# United States Patent and Trademark Office

| APPLICATION NO.         | FILING DATE            | FIRST NAMED INVENTOR | ATTORNEY DOCKET NO. | CONFIRMATION NO. |
|-------------------------|------------------------|----------------------|---------------------|------------------|
| 10/764,788              | 01/26/2004             | Edward L. Gibbs      | 016                 | 9762             |

| Same and the same | I A 1: 0: N  |  |  |  |  |
|---|--|--|--|--|--|
| Office Action Summary   | Examiner   | Art Unit   |  |  |  |

## **DETAILED ACTION**

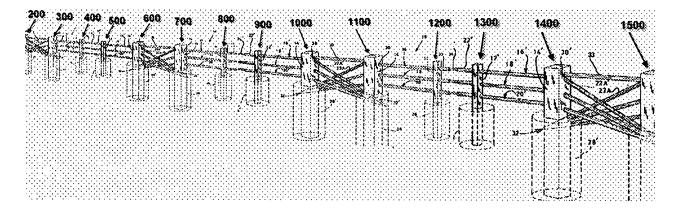
Claims 9-20 are rejected under 35 U.S.C. 103(a) as being unpatentable over Crisp (U.S. Patent 4,979,817) (see marked-up duplicated drawing below).

Claims 9-20. Figure 1 of Crisp shows a fence with a length of about 200 ft (since each cable is about 100 ft, col.3, Il.30-35). The cutaway ends of the figure 1 assembly imply that the fence continues for a length greater than that expressly shown in figure 1, however the exact length is not expressly stated. Crisp states that the fence surrounds property to secure larger areas such as diplomatic embassies (col.1, Il.10-15; 40-45 and col.2, Il.59-62). One of ordinary skill in the art at the time the invention was made would have easily recognized that surrounding the perimeter of an area such as a diplomatic embassy would require repeatedly duplicating the figure 1 assemblage of Crisp to obtain a fence long enough to surround an embassy. It has generally been recognized that duplicating the components of a prior art device is a design consideration within the skill of the art. In re Harza, 274 F.2d 669, 124 USPQ 378 (CCPA 1960). Therefore, it would have been obvious to one with ordinary skill in the art at the time the invention was made to repeatedly duplicate the figure 1 fence portion of Crisp, for the disclosed benefit of surrounding a large area such as an embassy, since such practice is a design

consideration within the skill of the art. Such modification would necessarily result in the

marked-up duplicated version of figure 1 shown above, wherein in addition to the first plurality

of posts (300-600) there is a second plurality of posts (700-1000) and third plurality of posts

(1100-1400); and in addition to the first rail system (bottom 24) there is a second rail system

(middle 24) and third rail system (top 24). This modified version of Crisp suggests all of the

limitations of claims 9-20 as best understood by the examiner. See 35 U.S.C. 112 rejection
